Suburban Rail Loop East Precincts Standing Advisory Committee

Volume 5: Burwood Precinct

Advisory Committee Report

Figure 5 Day 3 version of Map 1 to PRZ2: Use and Development Framework Plan (with Lot numbers added)

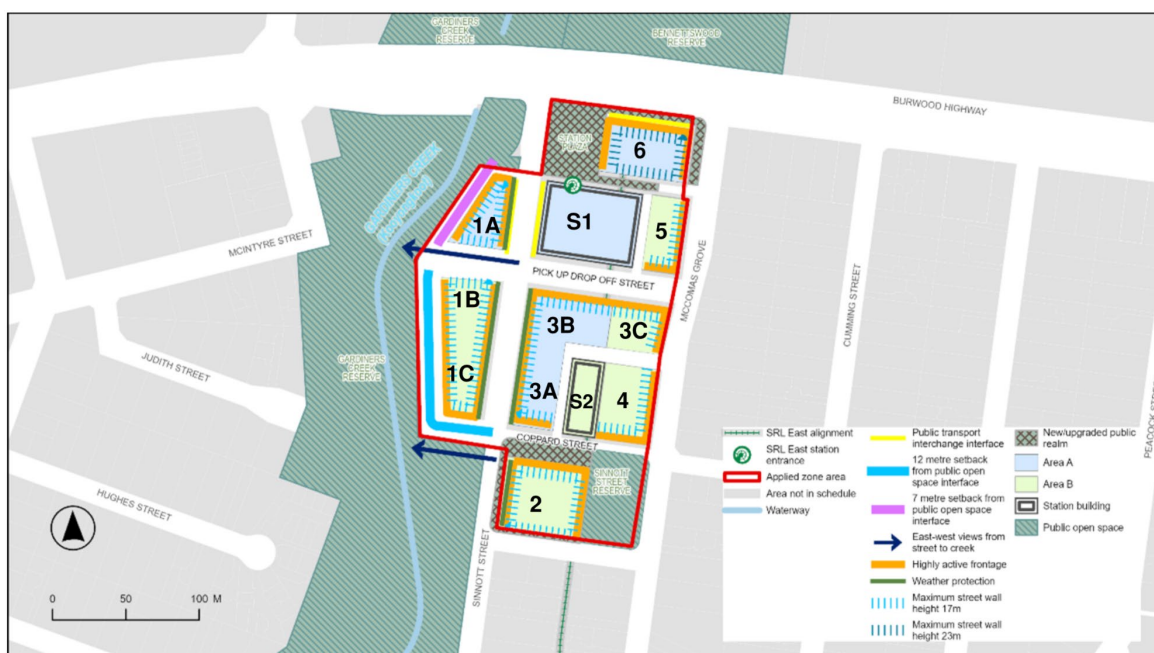
The Proponent generally accepted Mr Sheppard's recommendations and these are reflected in the Proponent's Day 3 version of the PRZ2 (Figure 5). Area A is noted as having a maximum building height of 69 metres and Area B 41 metres.

Figure 6 McGauran proposed heights to Map 1 of PRZ2

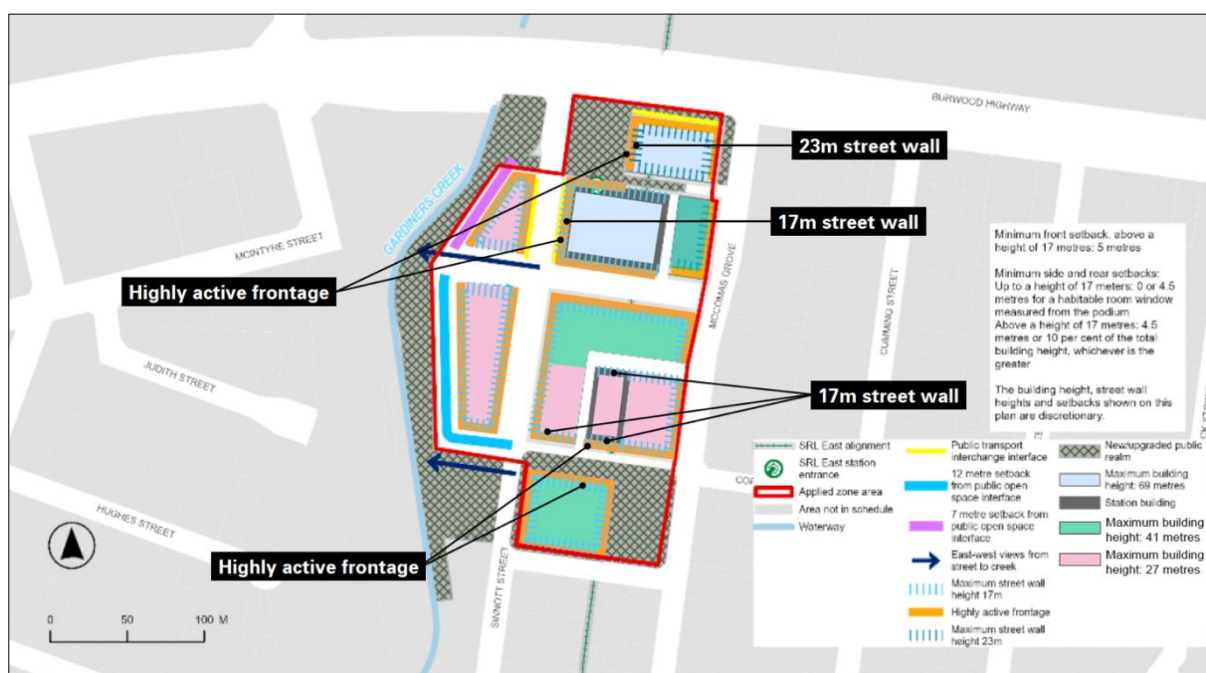
Prof McGauran recommended building heights of 27 metres, 41 metres and 69 metres across the SDA. While he accepted that higher density is appropriate closest to the SRL station, he did not support the 69-metre blanket preferred height control on the basis that it risks undermining pedestrian amenity, human scale and public realm quality if applied too broadly. He said his modelling demonstrated that heights of around 41

metres within the centre of the SDA would be appropriate and 41 metres could accommodate substantial density while still achieving acceptable solar access, transition and interface outcomes adjacent to key streets and open spaces. Where development directly interfaces with Sinnott Street Reserve, the Gardiners Creek corridor and primary pedestrian environments, he recommended lower heights of approximately 27 metres to protect winter solstice sunlight, support activation of streets and reserves, and deliver a more comfortable, human-scaled public realm. At the interface to Gardiners Creek, he considered built form needed to remain lower and then step up, to ensure the creek corridor is not overwhelmed or overshadowed. (Figure 6 and Figure 7).

Figure 8 Fountain Court site

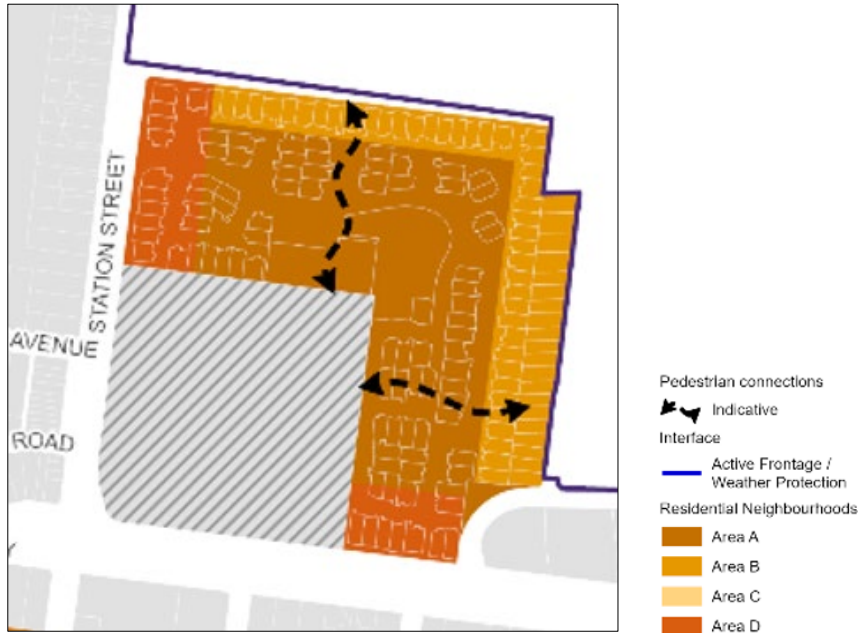
- Area D: 27 metres, with the exception of 21 metres for a depth of 20 metres from Bronte Avenue.

This is reflective of Mr Sheppard's evidence and is depicted in the Day 3 BFO3 and Figure 8 below.

Figure 9 BFO13 and BFO14 interface at Barlyn Road

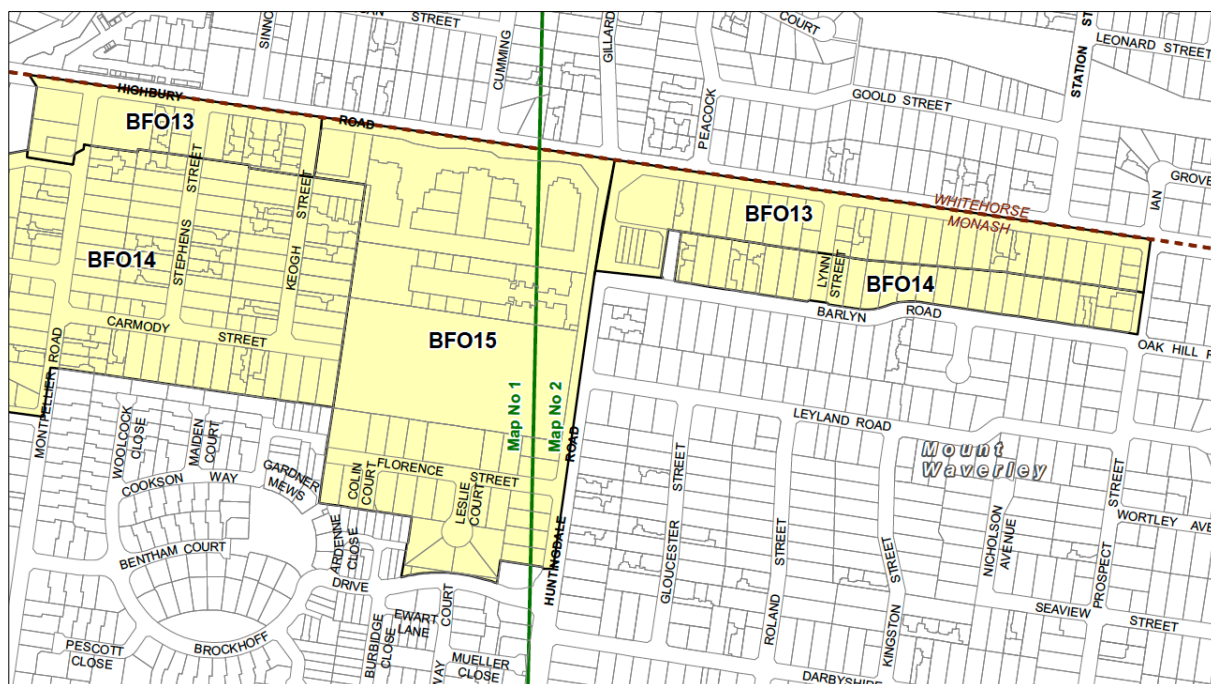
Monash Council raised concerns about the interface between the BFO13 (Key Movement Corridors) and BFO14 (Residential Neighbourhoods) areas, such as along Highbury Road (BFO13), and the interface with the residential area to the south including Barlyn Grove (BFO14). It submitted that the BFO13 preferred maximum height of 27 metres is about 2.5 times the BFO14 preferred height of 11 metres.

Monash Council raised concerns about the interface condition and impacts on the amenity of the residential area. It considered overshadowing would appear to be acceptable, but was concerned about the built form relationship, noting that if land in the residential area was not developed the difference would be even more stark. It suggested providing a greater setback in the mid-rise tower element to avoid a 'wedding cake' appearance and make the built form appear more recessive.

In relation to Barlyn Road, the preferred maximum building height in the Monash BFO13 relating to the section of Highbury Road between Huntingdale Road to the eastern edge of the Structure Plan Area should be 21 metres (and not 27 metres).

Figure 11 McGauran proposed links

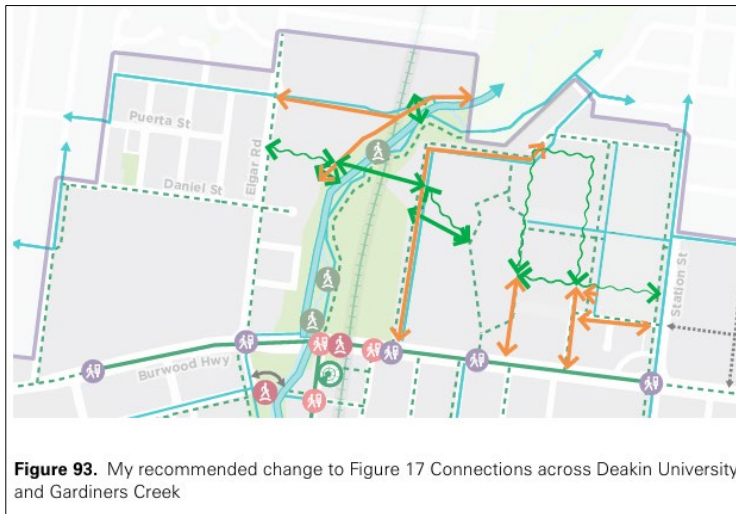
- it would be logical to leverage and extend existing road networks to and through the site if it is to be developed for more than a single user and purpose, to enhance walkability and vehicle access and egress
- there is merit in interconnecting walking networks around and through the site to the neighbouring streets and networks, including:
 - Glengarry Avenue and the Gardiners Creek corridor to the north-west
 - Station Street to the east
 - Deakin University to the west and Milford Avenue.

Prof McGauran's suggested links are shown in Figure 11.

The Committee has carefully assessed the suggestions put forward and considers that the indicative location of the links could be altered as shown in Figure 13 below. (which generally reflect the links put forward by Prof McGauran).

Figure 12 Walsh proposed links

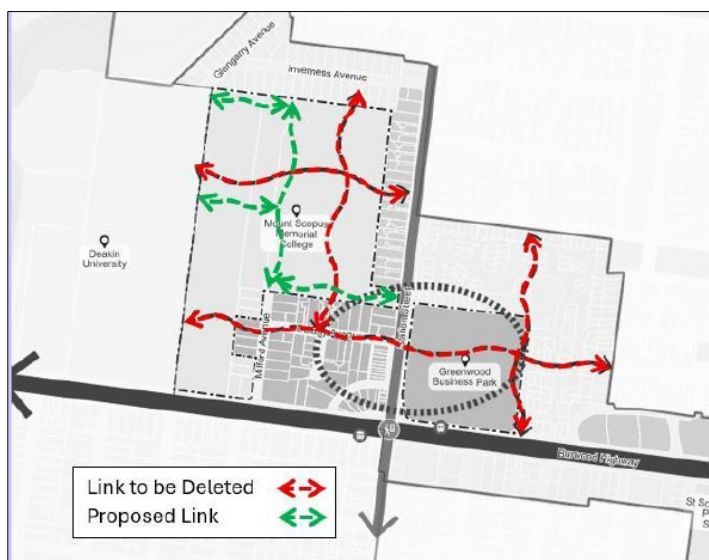
Mr Walsh said the Mount Scopus links can be rationalised so that they do not rely on development of individual properties outside the strategic site. He recommended the following changes (see Figure 12):

- removing the link on Delany Avenue as this already exists
- translating the north-south link to the west to use Milford Avenue
- using the existing road and pedestrian access from Station Street and extending this to the Milford Avenue north-south connection.

He noted that the links through to Deakin University would need to be provided in consultation with the University. Ms Marshall agreed in principle but noted that the links shown in the draft Structure Plan were indicative and did not need to be amended to achieve the outcomes described by Mr Walsh.

Figure 14 Thompson proposed links

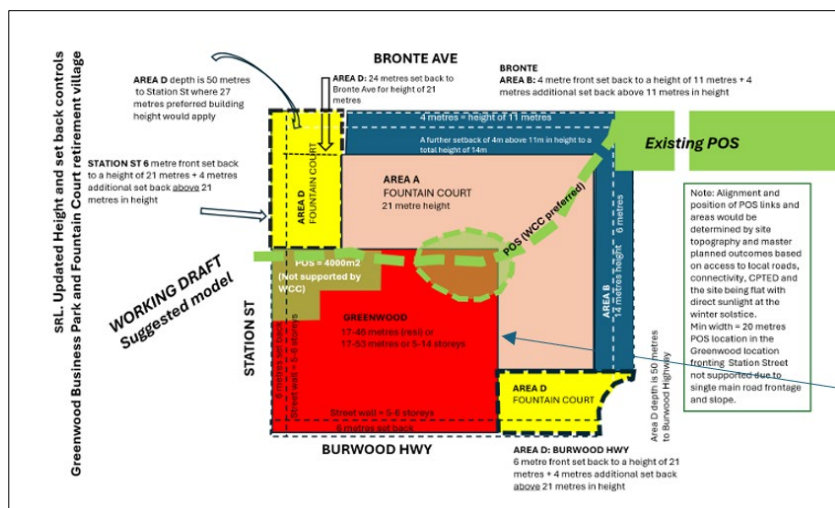
Ms Thompson, in considering open space issues, suggested a link would be better located running east-west along the north side of the Greenwood site, then diagonally joining Muyan (Poole Street) Reserve (see Figure 14). In cross-examination, Mr Walsh and Ms Marshall considered this link to be acceptable.

The Committee has carefully assessed the suggestions put forward and considers that the location of the links could be altered as shown in Figure 13 above.
